Engineering Change Order 0405 – Revised Drawbar

Applies from Serial Number 2190300 (US), 1190311 (AU)

Date of Change January 2019

1510-08

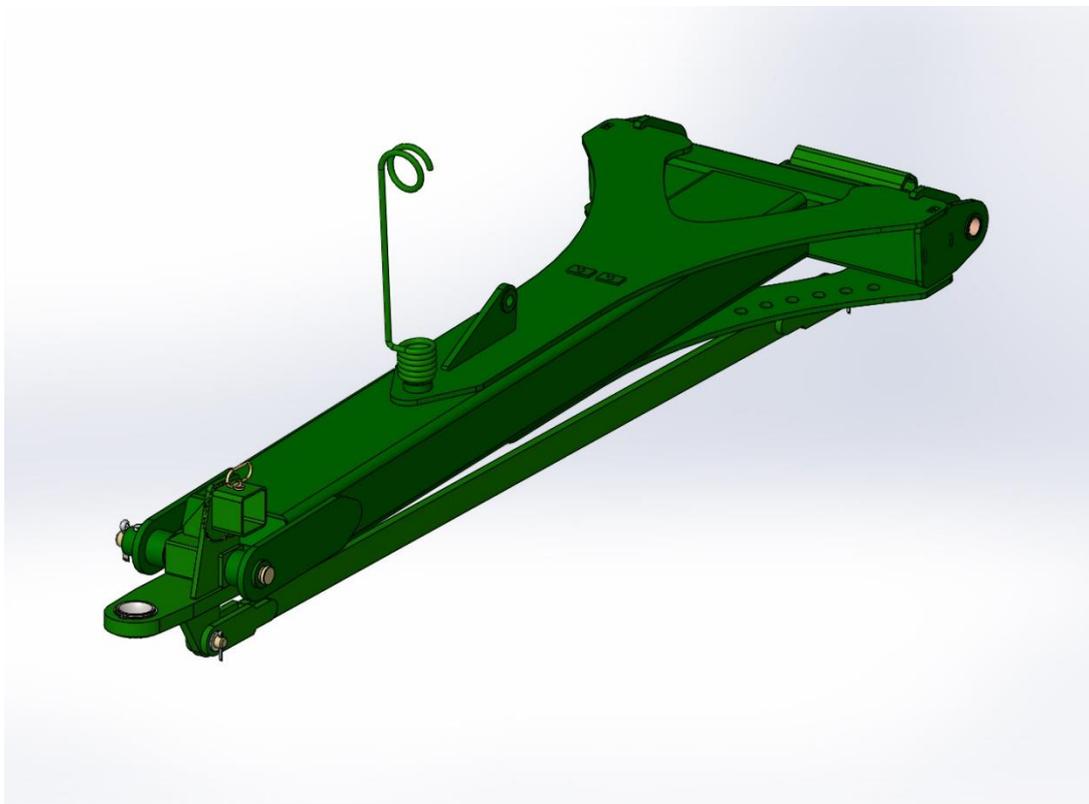
- Increased RHS section to 250x100x9mm
- Improved hose park & depth stop locations
- Improved resistance to lateral loads
- New spring hose mount
- New hitch pin
- Retrofittable to all machines

Replaces: 0810-08 (US/AU)

Machines Affected: 30', 9m, 40', 12m

1610-08

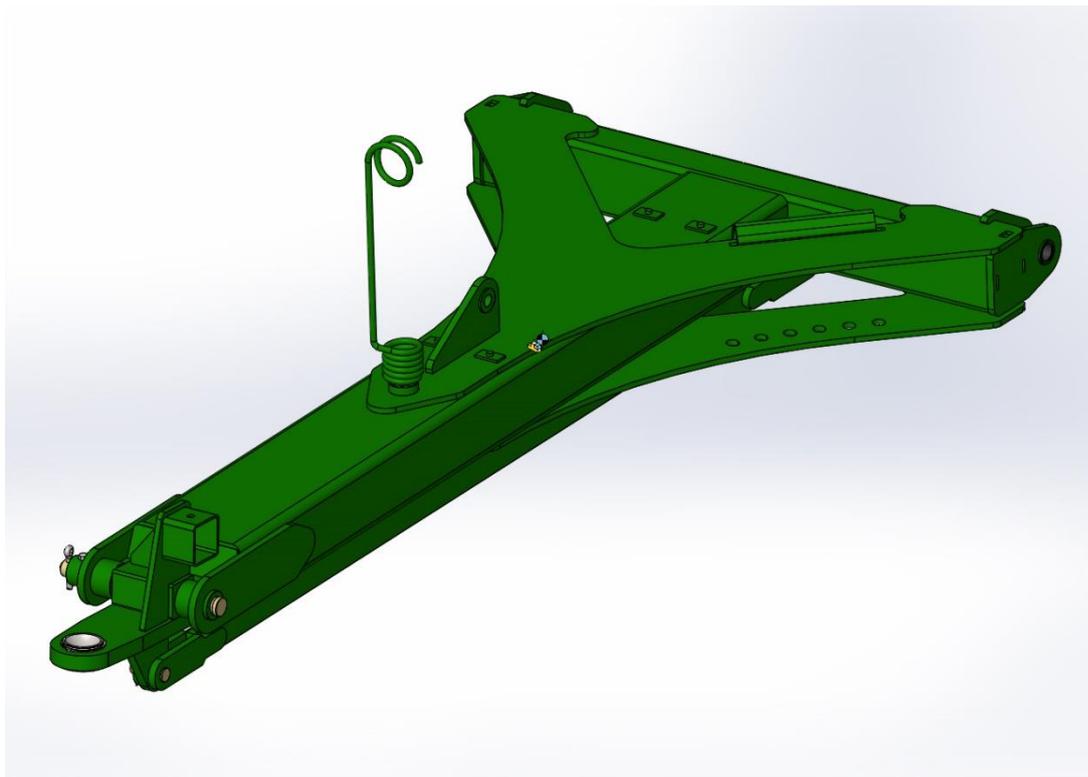
- Improved hose park & depth stop locations
- Improved resistance to lateral loads
- New spring hose mount
- New hitch pin
- Retrofittable to all machines

Replaces:	n/a
Machines Affected:	Model 46
Assembly Manuals Changed	Yes
Technical Bulletin	n/a
